SMDC Planning Reference –	SMD/2024/0423		
Site Name –	Greenfields Farm Battery Storage Facility		
Summary of proposals -	320 No. battery storage units and 80 No. transformer units and associated ancillary facilities including landscape planting proposals and acoustic fencing.		
Consultation Note Subject –	Landscape and Visual Matters		
Planning Case Officer –	Richard Wilshaw		
Landscape Comments Prepared By –	Stuart Ryder of Ryder Landscape Consultants		
Date of site visit —	27/2/25	Date of response(s)	30/3/25 Rev A 7/4/25 Rev B – 5/10/25 Rev C – 23/10/25
Summary of anticipated landscape and visual effect	There will be a Major, Adverse landscape effect at the Site at Year 0 that will reduce to a Major/Moderate, Adverse landscape effect during the operational life of the facility. However there would be a Moderate, Beneficial wider landscape effect from the more extensive landscape planting across the broader farm holding. Visual effects are considered to be limited with FP Cheddleton 49 experiencing the most notable visual change but also from Cheddleton 58

**SMD/2024/0423 - GREENFIELDS FARM BESS PROPOSALS – LANDSCAPE AND VISUAL CONSULTATION
Rev B**

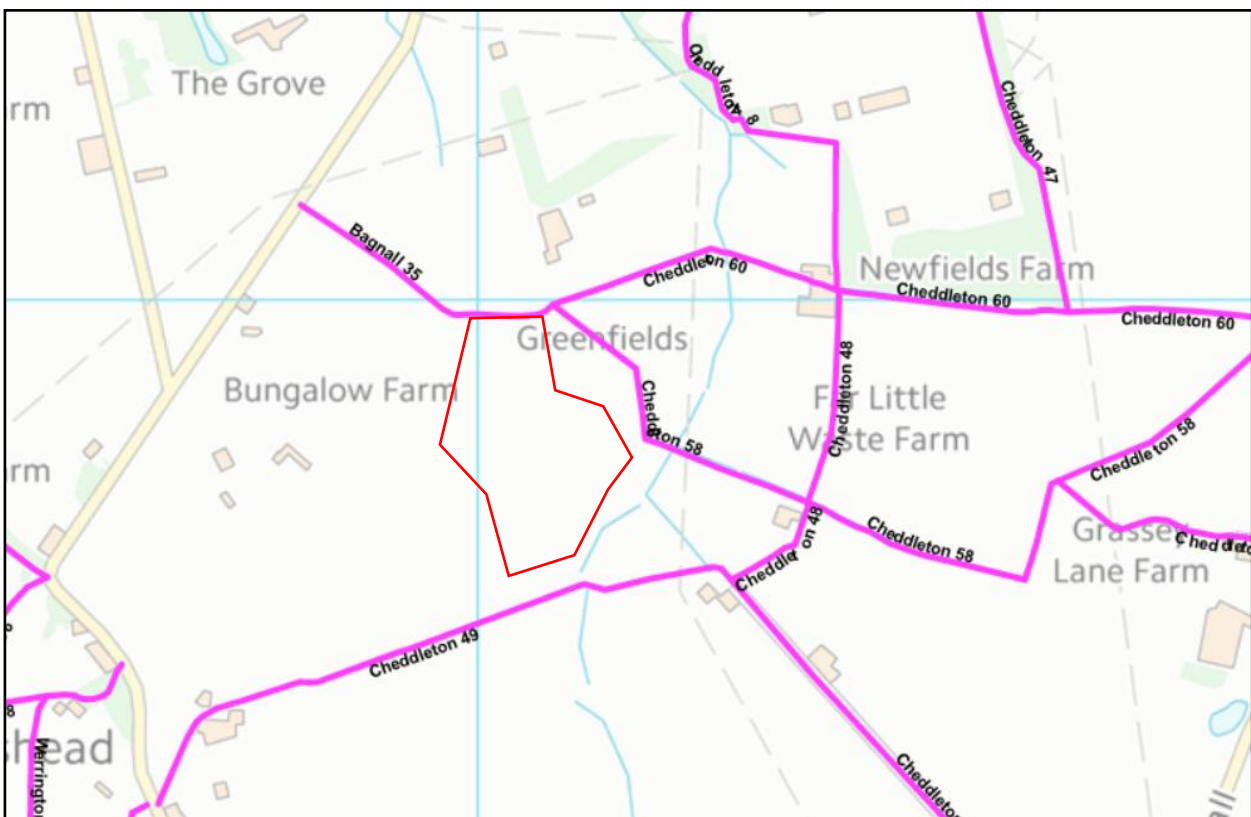
In comparing the Rev G version of the Detailed Soft Landscape Plan to the Rev E iteration the following principle changes are noted:

Removal of small battery yard in the north west field – this is welcomed as it allows retention of the existing field boundary and reduces the visual effects for receptors to the west of the Site.

Provision of a 1.5m high 1 in 3 bund in the north west field – also welcomed to assist with screening for receptors to the west.

Lowering the Gas Insulated Switchgear building by approximately 3 to 4.5m to set the building lower within the development. This is a positive move to reduce its visual effects and visible scale from nearby PROWs. However it will still be visible from the paths and more architectural information would assist to allow assessment of its end appearance.

Bunding to south side of the south west and eastern battery yards – this is welcomed in principle but its forms should not be a 1 in 3 – 1 in 3 trapezoidal embankment but should be viewed as more land form with sweeping ends to the bunds and variety to the 1 in 3 form – please see attached scan. A specific Planning Condition is included and the inclusion of LDA's Landscape Architects in the design of the bunds form is encouraged.

A second tree and hedge line is included closer to the eastern edge of the battery yards – again welcomed as a way of building up screening layers in the landscape.
